JONES & BEACH ENGINEERS INC.

**RE: TAC Response Letter
375 Banfield Road, Portsmouth, NH
Tax Map 266, Lot 7
JBE Project No. 19190.2**

We are in receipt of comments from Stefanie Casella, Town Planner, dated August 2, 2021. Review comments are listed below with our responses in bold.

TEXTURED PAVEMENT DETAIL

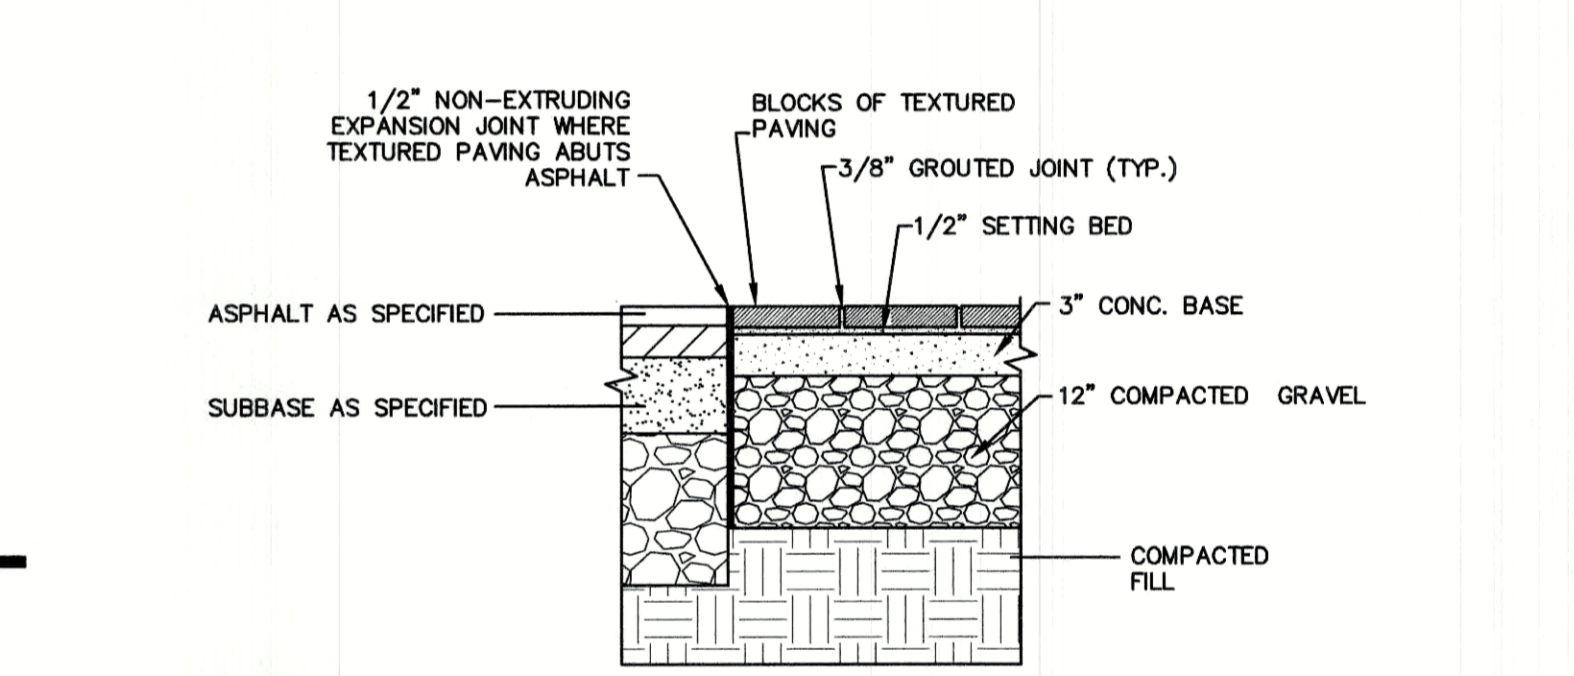
6. *Can an alternative paving material (i.e. cobblestones or textured paving be used for the wide radii along Banfield Road?*

RESPONSE: Textured paving has been specified.

DRAWING No.
T3
 SHEET 22 OF 24
 JBE PROJECT NO. 19190.2

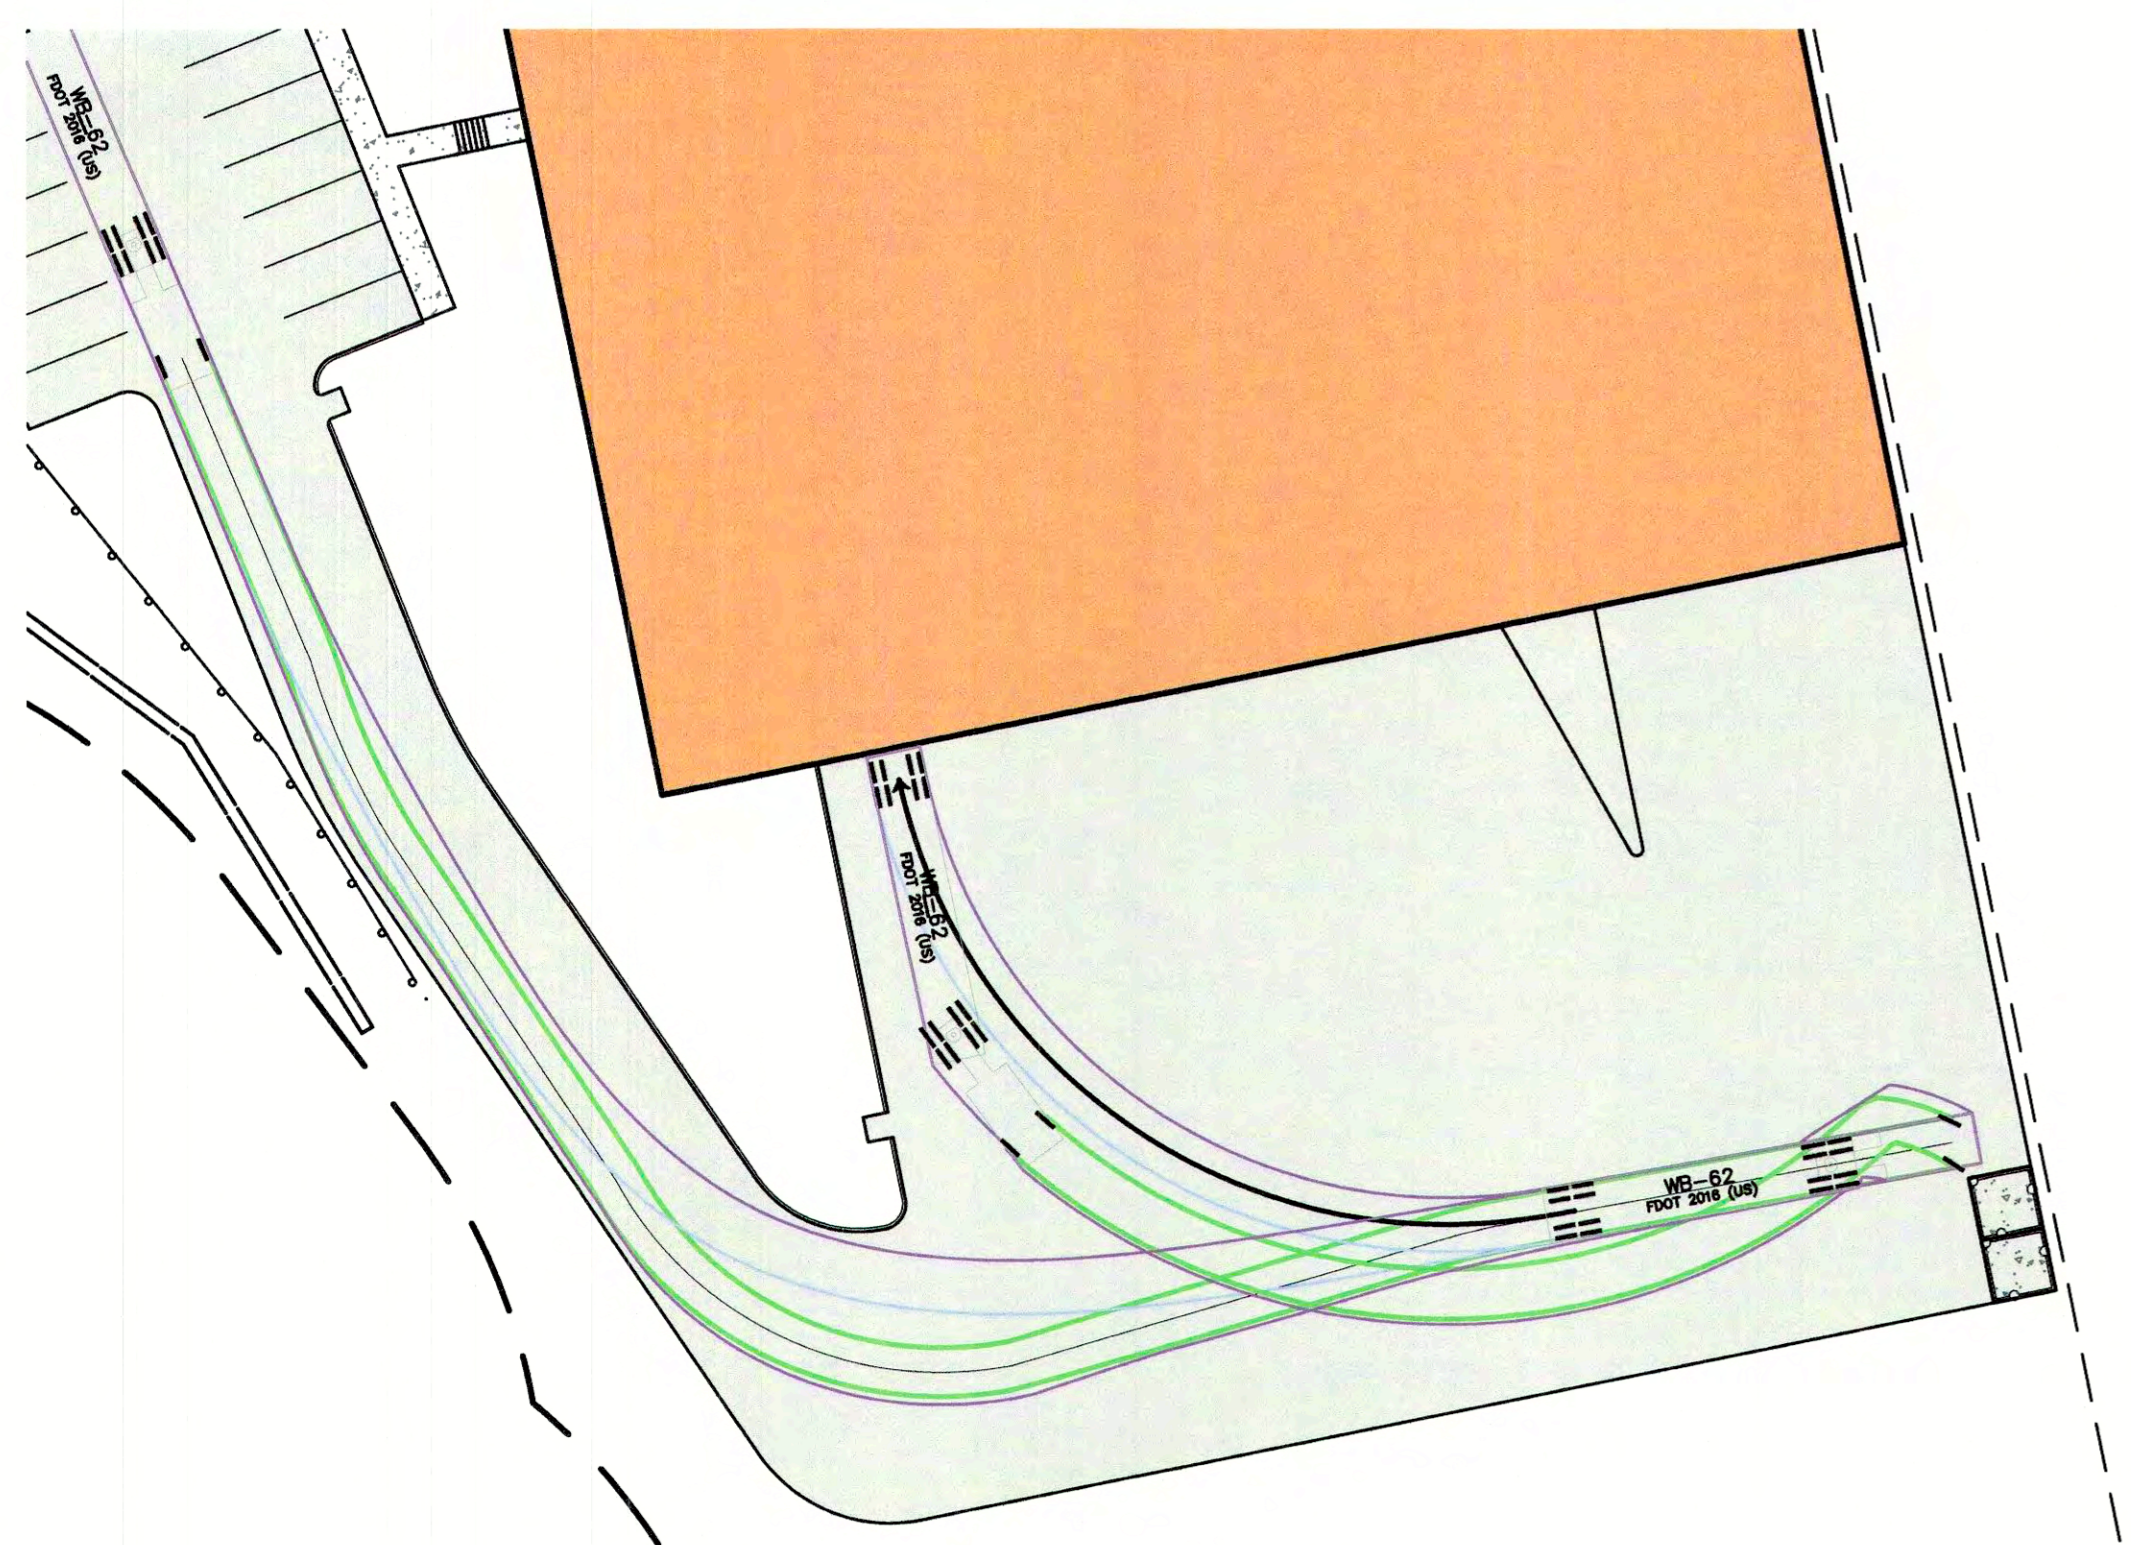
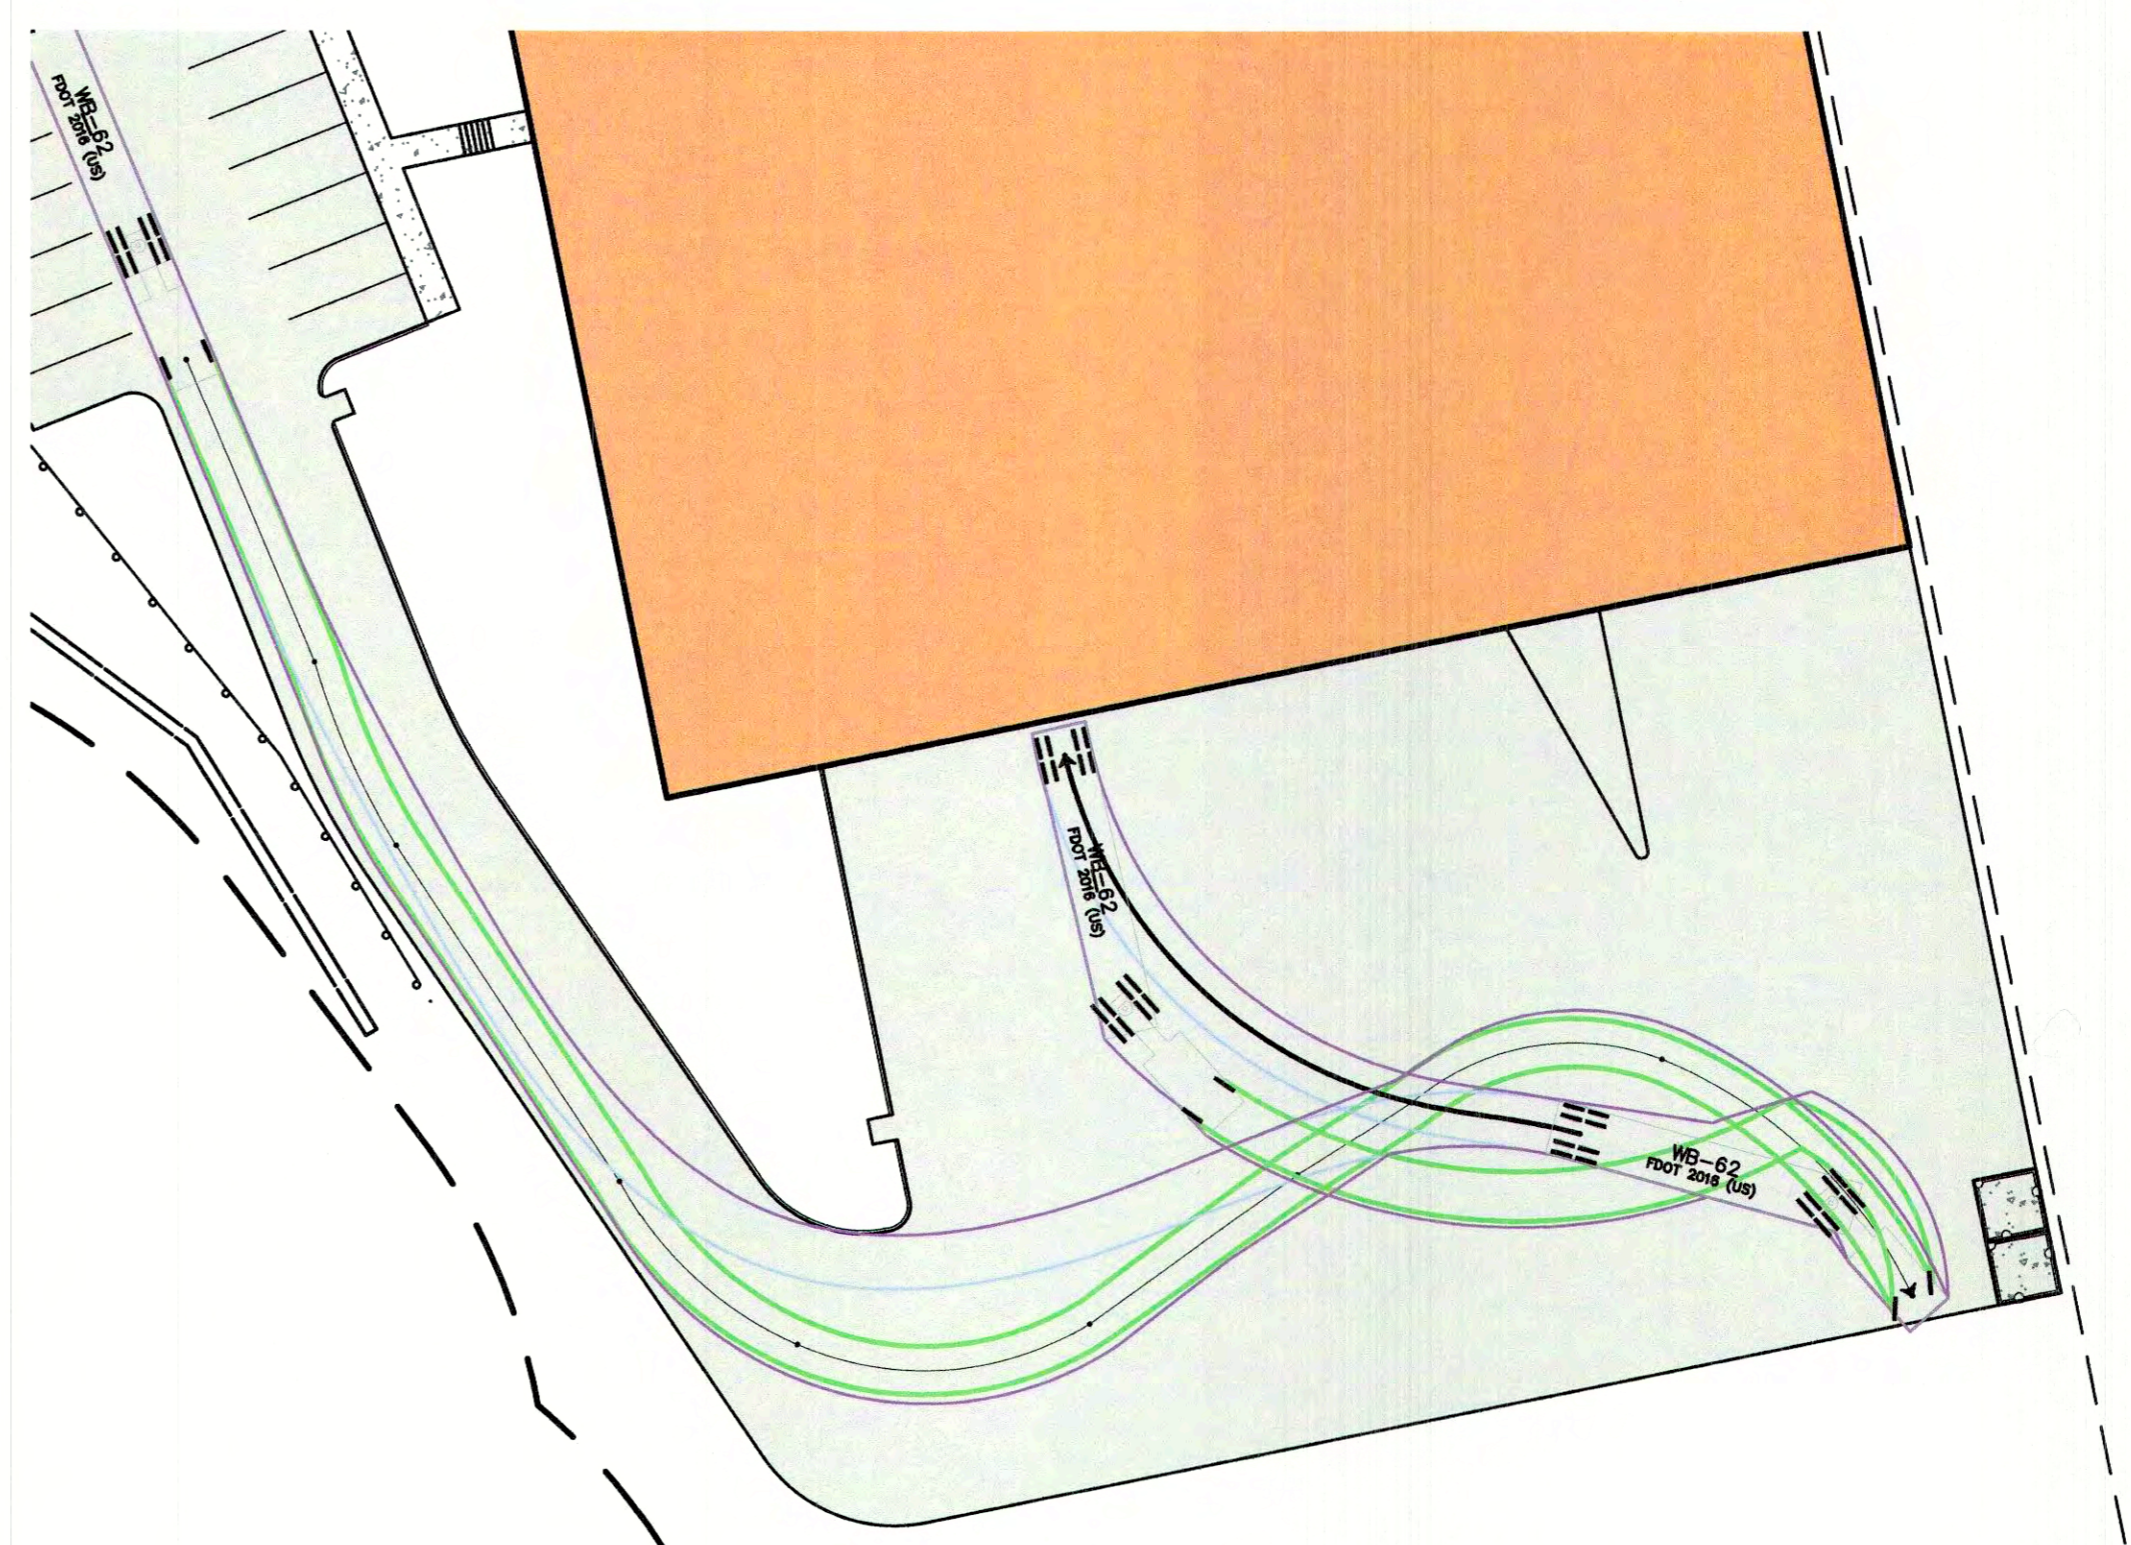
5. *How do trucks navigate the turning movements to all the loading docks?*

RESPONSE: See Sheet T3 with simulations of a WB-62 accessing different loading dock locations.
